VERSION	00	11/2010	First version

Document n°	FRN-SB2010-09-washer for outer glass breaking- SC ovens								
Brandt	Smeg								
Models involved	SCP112N-8	SCT109N-8	SAP112-8	SC106-8	SC107SG-8	SCP113-8			
	SCP109N-8	SCT109B-8	SA109-8	SC106SG-8	SC109-8	SCP113SG8			
	SC106B-8	SC107N-8	SA112-8	SC106PZ-8	SC109SG-8	SCT105-8			
	SC106N-8	SC109N-8	SAP109-8	SCT109-8	SA109M-8	SCT105SG8			
	SC112N-8	SCP108RB8	SCP112-8	SCP112PZ8	SAP109M-8	SAP109-9			
	SC112B-8	SCP108RN8	SCP109-8	SC112PZ-8	SCP12-8				
	SCP112B-8	SCP113N-8	SCP109SG8	SCT109SG8	SCP108R-8				
	SCP109B-8	SCT105N8	SC112-8	SCP112SG8	SCP108RS8				
Cause	The wrong plastic bush position, which protects the glass (that is to say lower than the inner slot of the handle support) and the stretch occurring during the handle fixing, can affect the outer glass.								
	See the following pictures.								
Description of the modification	Put an additional washer p/n 764130572 into the two handle supports , under the bush protecting the glass . Follow the instructions hereafter.

Date of introduction	01/10/2010

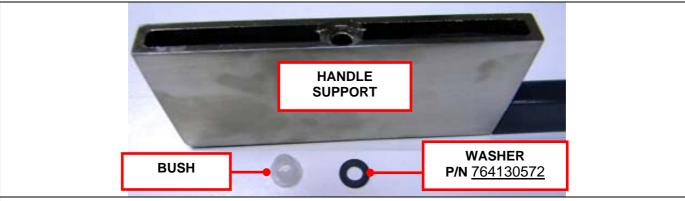
1. Remove the handle and the two bushes from its place (fitted into the handle supports).

5. Side view of the bush fitted into the handle support.

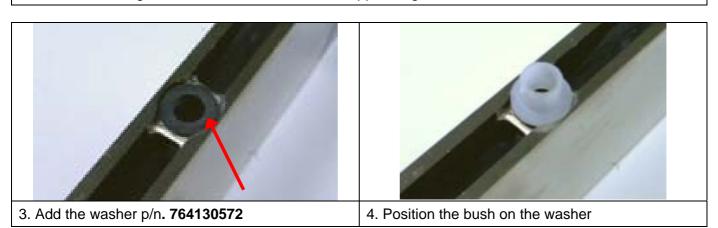
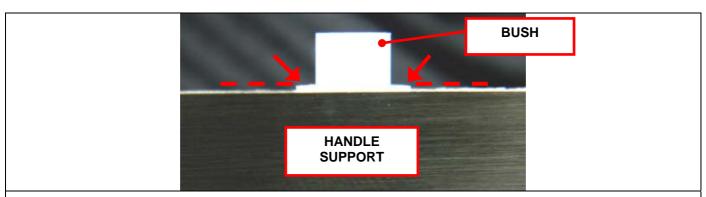
For the appliances produced **before the 1st October 2010**, owing to a outer door glass breaking, carry out the following checks and apply the washer p/n **764130572**. (under the bush which protects the glass for each handle support, right and left)

2. Add a washer p/n **764130572** between the handle support and the bush (for both supports) in order to align the bush base to the handle support edge.

When the handle support is fixed, lift the bush and the washer up in order to avoid mechanic shock on the door outer glass. Repeat the procedure for the opposite handle support.
